UNITED STATES NUCLEAR REGULATORY COMMISSION WASHINGTON, D. C. 20555

) home a copy DAG WAIVER OF CPCK REVIEW OF A PROPOSED GENERIC LETTER ON THE MODIFICATION OF THE SURVEILLANCE INTERVAL REQUIREMENTS FOR THE TECHNICAL SPECIFICATION ON ELECTRICAL PROTECTIVE ASSEMBLIES

SUBJECT: MODIFICATION OF SURVEILLANCE INTERVAL FOR THE ELECTRICAL PROTECTIVE ASSEMBLIES IN REACTOR PROTECTION SYSTEM POWER SUPPLIES (Generic Letter 91-)

December 15, 1988 NMP2L 1184

FAILURE SEQUENCE REQUIRED FOR CORE DAMAGE DUE TO FAILURE OF RPS M/G SET PROTECTIVE CIRCUITRY

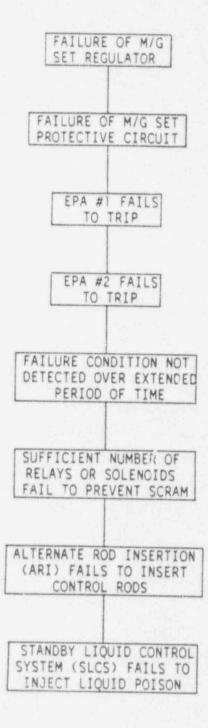
The change in reactor shutdown reliability when EPA surveillance test intervals are extended was calculated using the failure model given in Figure 1 and failure probabilities from industry operating experience. For the RPS Scram Solenoids, the following conditions are required for a reactor shutdown failure in a single M/G set circuit:

- Failure of M/G set regulator causing under/over voltage or under frequency
- Failure of M/G set protective circuit
- ° EPA #1 fails to trip
- ° EPA #2 fails to trip
- [°] Under/over voltage or under frequency condition not detected over an extended time period
- Sufficient number of logic relays or scram solenoids fail so as to prevent scram
- * Alternate Rod Insertion fails to insert control rods
- Failure to inject liquid poison from Standby Liquid Control System

The incremental change in the failure probability of the RPS Scram Solenoid primary scram system when the EPA surveillance test intervals are extended from 6 to the proposed maximum of 18 months was calculated to be 4.7E-08 failures per reactor-year. The incremental change in core damage frequency due to the 18-month extension includes coincident failure of the Alternate Rod Insertion system and Standby Liquid Control System (required for reactor shutdown failure), in addition to the failure of the primary scram system. When credit for these two systems is included in the calculation, the incremental change in core damage frequency resulting from extending the Scram Solenoid EPA test intervals to 18 months is 6.2E-12/reactor-year. This incremental change in core damage frequency when the EPA surveillance test intervals are extended from 6 to 18 months is a negligible contributor to overall plant safety risks.
